Parts Techline: 2014-PT279
From: Parts Technical

VE/WM Rear Side Door Replacement

1) Rear Side Doors

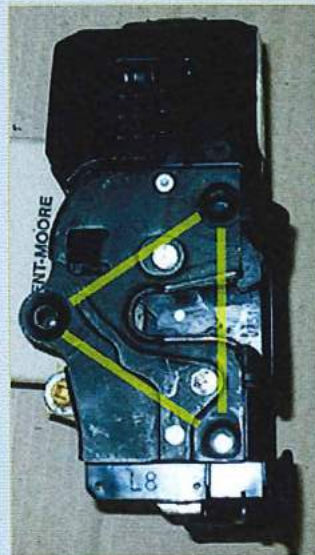
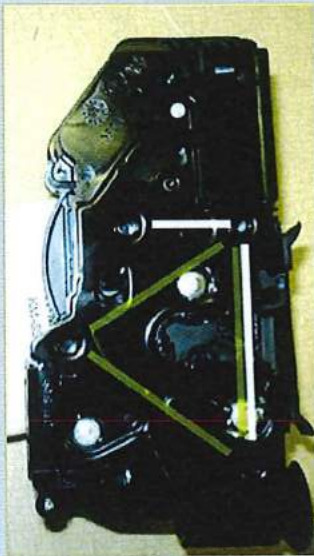
The new service door has three latch mounting points in an "L-shaped pattern" (see holes linked by white lines in below photo on the right). The production door design had three latch mounting points in a "triangular pattern" (see holes linked by yellow "triangular pattern lines" in below photo on the left).

4) Plugs for door handle access holes

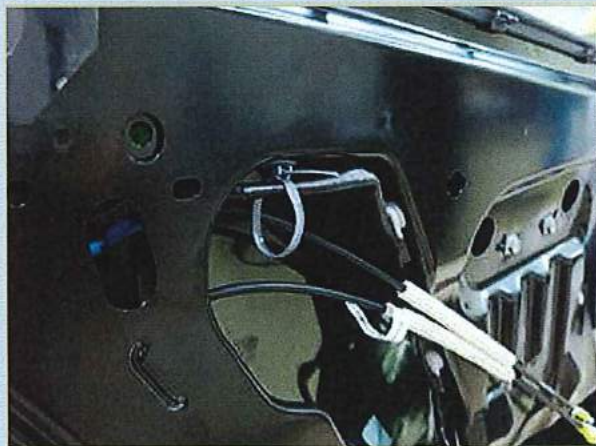
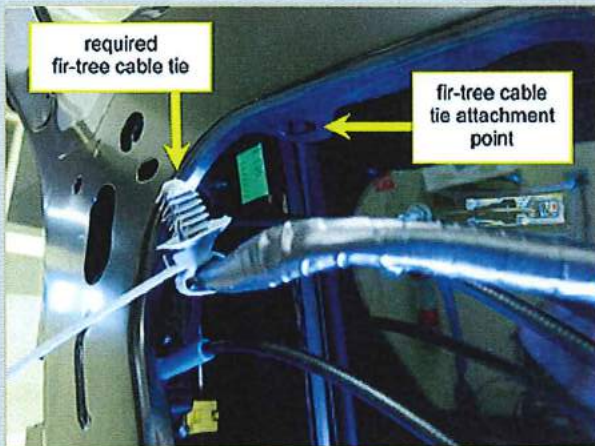
The 10mm diameter hole nearest to the door skin (shown with yellow arrow) was not present on original doors. This plug needs to be ordered and fitted for new service doors.

6) Door trim retention

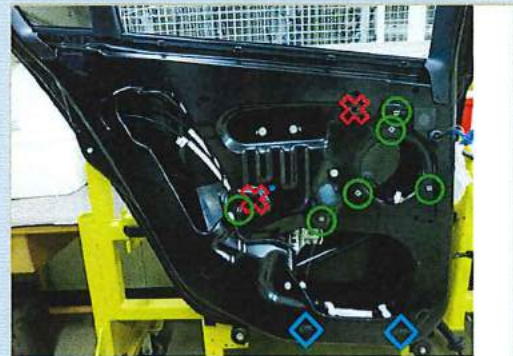
Due to the new service door inner panel being a common design with VF/WN you need to identify the VE/WM door trim retention holes and install the appropriate retainers in these holes only. Refer to the below photo regarding the location of retainers. Installing retainers in the wrong holes will result in rattles and/or inability to retain the door trim correctly.

-  Door trim attachment push-in steel nut with rubber seal – p/n 11610510 – quantity 2
-  Speaker / inside handle / pull cup push-in nylon nut – p/n 90230846 – quantity 6
-  Do not use – VF only
